**PROCUREMENT OF EQUIPMENT FOR GENERAL HOSPITAL IN
ARANDJELOVAC
(PROCUREMENT NO. IOP/60-2021/UHI)
11th April 2022**

Clarification no. 4

Regarding the list of questions that the Employer, Public Investment Management Office Belgrade, No. 11 Nemanjina street, have received from the potential bidders, concerning the procurement procedure: **Procurement of equipment for General Hospital in Arandjelovac** IOP/60-2021/UHI, we give you the following answers:

1.23. Three-seater for the relaxation

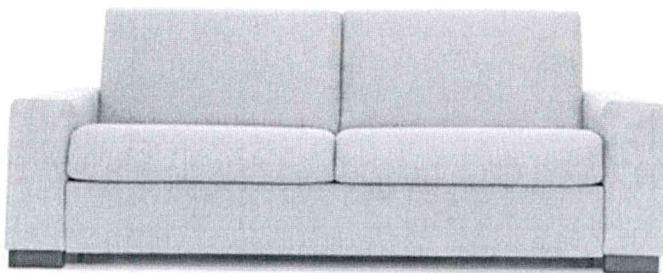
Should three-seater be stretchable?

Answer: It is a fixed three-seater and it does not need to be converted. Picture attached.

1.47-Two-seater for the relahation

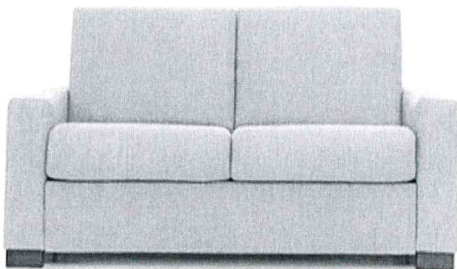
Should two-seater be streachable?

Answer: It is a fixed two-seater which does not need to be converted. Picture attached.

Waste needles bin holder (bin volume 2-3 lit.)

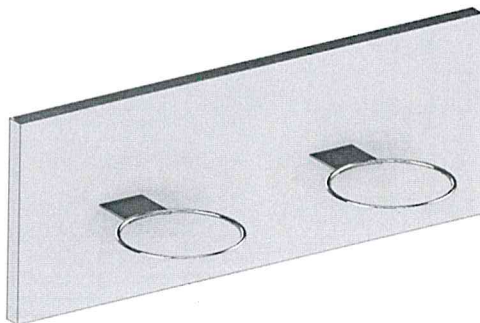
Is there a picture of the requested item?

Answer: Picture attached.

1.57.-Equipment holder

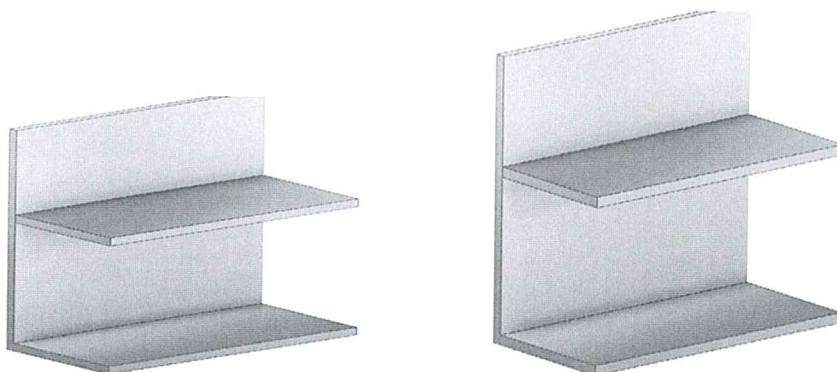
Is there a picture of the requested item?

Answer: Picture attached
